## Report to the Future Melbourne (Planning) Committee

### Ministerial Planning Referral: TPM-2015-1/A 32-44 Flinders Street, Melbourne

1 September 2020

### MINISTERIAL PLANNING REFERRAL

Figure 5: Proposed ground floor plan (source: application plans prepared by Bates Smart)

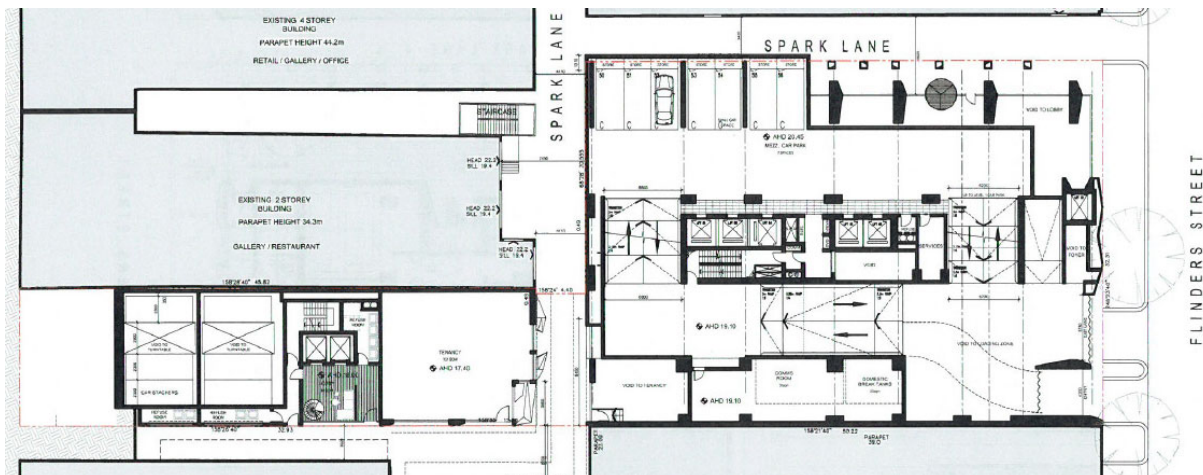
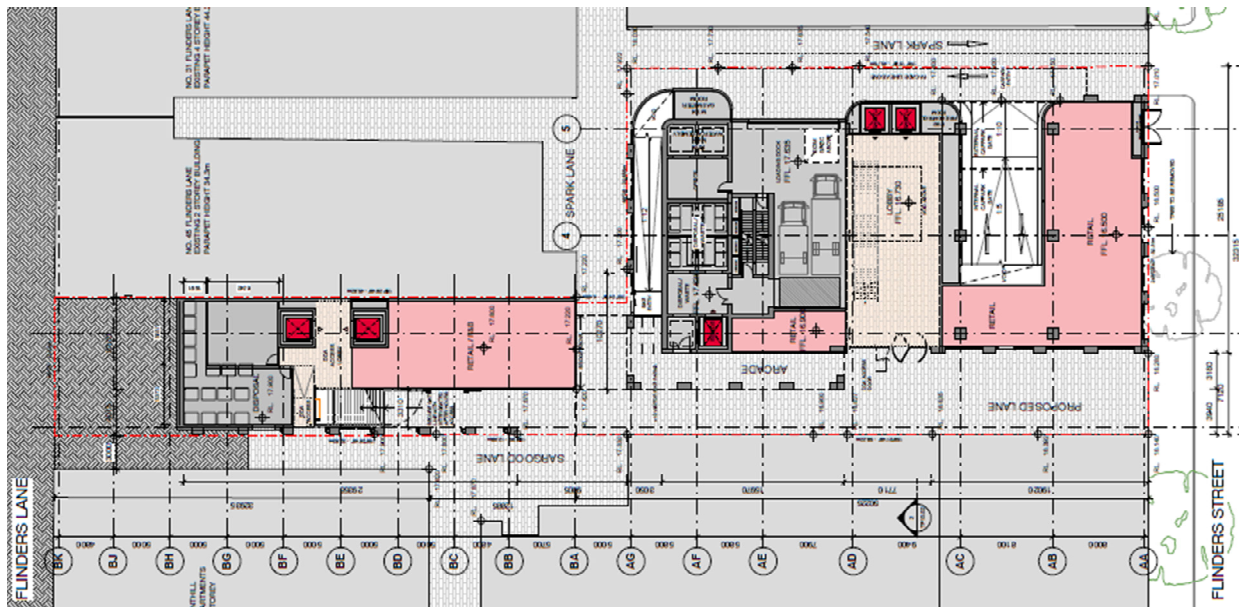
- The reconfiguration of the ground level of the building, including the re-location of the car park entry to Spark Lane and the resultant further activation of the Flinders Street frontage. The width of Spark Lane would also be increased to 6.2 metres to allow for two-way vehicle movements.

The now reduced ground floor level would also allow for the provision of a pedestrian thru-block link along the western property boundary between Flinders Street and Flinders Lane. Figure 4, 5 and 6 show the approved ground floor plan, the proposed ground floor plan and altered access arrangements through the site respectively.

Figure 7: Approved and proposed typical tower floor plans - Flinders Street building  
(source: application plans by Bates Smart)

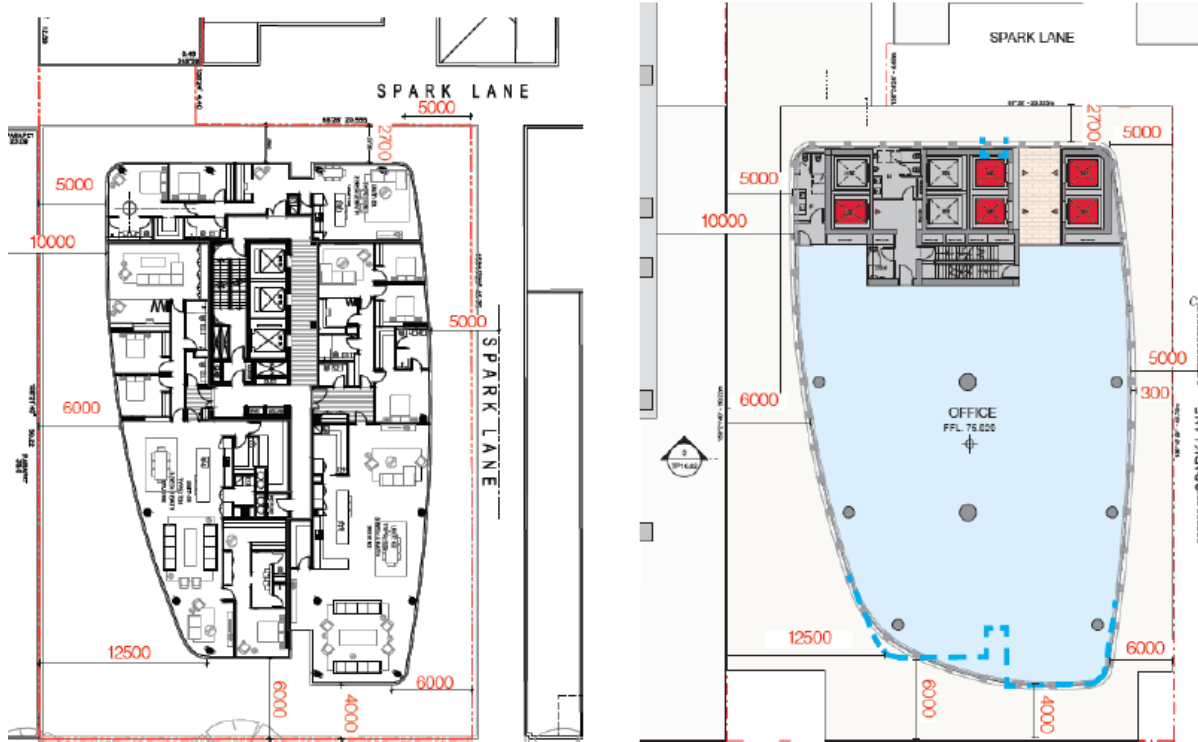
- Though the form of the Flinders Street tower would remain largely as previously approved, the feature 'notches' marking its north and south elevations would be removed. The change of use of the tower (to office) would also result in alterations to its presentation.

As shown in Figure 7, the Finders Street tower would be setback four metres only from the street boundary. Though this is less than the five metres otherwise required, the proposed setback is no less than that previously approved. To this end, the extent of non-compliance here has not been increased.

Similarly, the setbacks of the tower from the centre line of Spark Lane to the east and the western property boundary also match those previously approved and exceed the Modified Requirements of Table 3 (six and 10 metres respectively).

Figure 10: Approved and proposed typical tower floor plans - Flinders Lane building  
(source: application plans by Bates Smart)

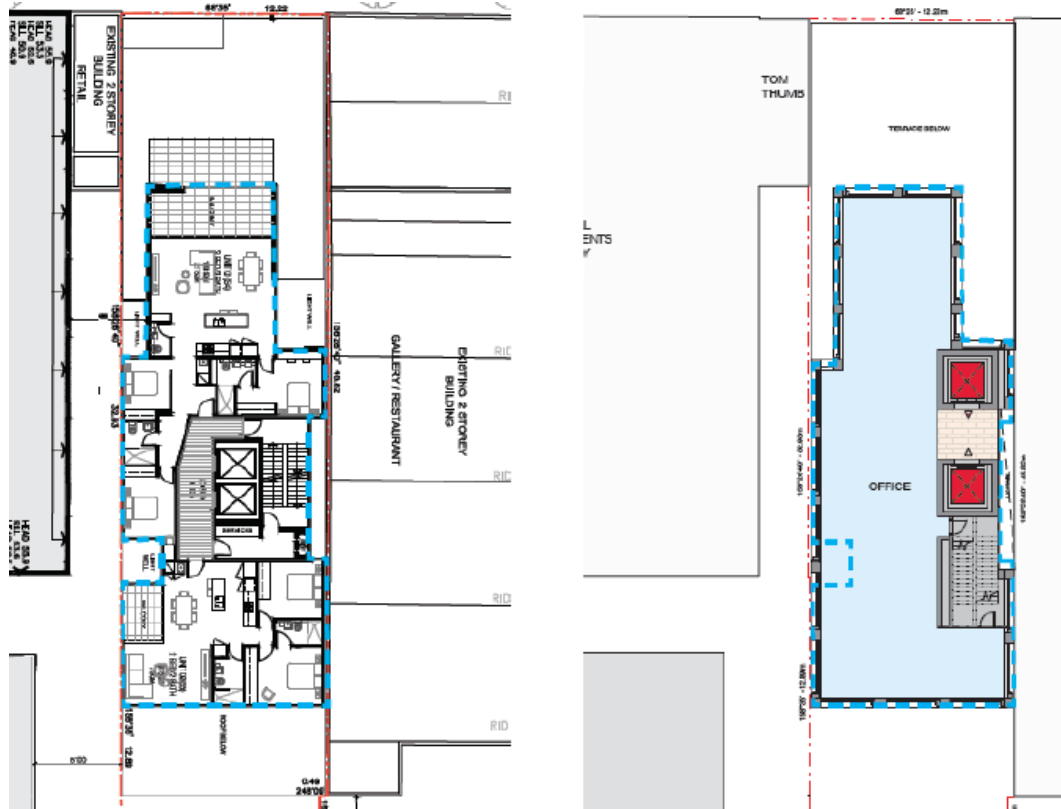
- The reconfiguration of the Flinders Lane tower, including the deletion of the light well along the western boundary and the part extension of the tower over space vacated by now deleted north-facing terraces. The presentation of the tower would also now be altered to reflect its new use (office).

As shown in Figure 10, the form of the Flinders Lane tower would also largely be retained. To this end, only its street setback would be reduced. This setback (now 9.8 metres) will however continue to comply with the Modified Requirement of Table 3.

With regard to the Flinders Lane podium, it is noted that the approved street wall height (24 metres) will again be retained. Though the light well adjacent to the western property boundary will now be deleted, this will be replaced by a largely permeable multi-storey colonnade (refer Figure 15). It is considered that this feature will provide the facing residents of Manhattan Apartments with an increased sense of visual relief and as such represents a built form and amenity improvement.

Figure 16: Section showing thru-block link extending from Flinders Street to Flinders Lane  
(source: application plans prepared by Bates Smart)

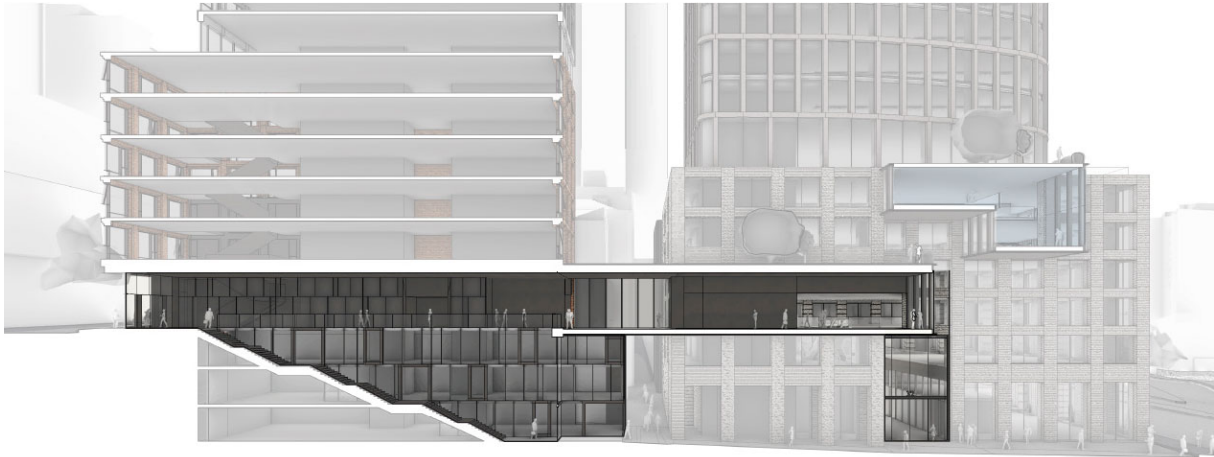
- The proposed pedestrian thru-block link extending between Flinders Street and Flinders Lane is welcome.
- Notwithstanding this, a comprehensive public realm / landscape plan should be submitted showing the finer grain qualities of this link.
- Shadow diagrams demonstrating the level of sunlight that would penetrate the link should also be submitted for further consideration.
- An active retail / food and drink use should be provided along the Flinders Lane frontage to provide greater pedestrian continuity and legibility.
- Multiple, finer-grain retail / food and drink uses should be provided along the length of the link.

Though Council's Urban Designers have requested a condition be included upon any amended permit issued requiring the submission of a comprehensive landscape / public realm plan further detailing the thru-block link, it is noted that existing Condition 43 already serves this purpose. It is recommended however that this condition be amended to reflect the link now proposed, as opposed to the public spaces previously approved and referred to by this condition (refer overleaf).

Again, existing Condition 43 could reasonably be amended and applied to the new link. To this end, details of all materials, signage and landscaping along its length should be required for further assessment to ensure the highest possible design quality and, in turn, amenity value. This, together with the increased level of sunlight now proposed, will provide for a satisfactory pedestrian experience.

Whilst Urban Design has also recommended a number of smaller scale retail / food and drink premises be provided along the length of the link, it is considered that the proposed extent of activation is sufficient. This includes the provision of three retail / food and drink premises at Flinders Street level, an additional retail space at Level 01 and a further space at Flinders Lane level. These tenancies will together engage pedestrians passing through the various levels of the site between Flinders Street and Flinders Lane and provide for the continuity and legibility sought by Urban Design.

- Conditions 32 and 33 (Public access and the vesting of Spark Lane) - As requested, these conditions can be deleted on the basis both are now redundant. A new condition (48) should however be added in their place requiring the applicant to enter into a legal agreement with Council in accordance with Section 173 of the *Planning and Environment Act 1987* requiring the thru-block link to remain publicly accessible.

*Before the development starts, excluding demolition and bulk excavation and site preparation, a Landscape and Public Realm Plan must be submitted to and be approved in writing by the Responsible Authority in consultation with Melbourne City Council. When approved, the plan will be endorsed and will then form part of the permit. The plan must be drawn to scale with dimensions and be generally in accordance with the amended plans prepared by Bates Smart numbered TP01.20 to TP09.03 inclusive and dated 22 January 2020 but amended to show:*
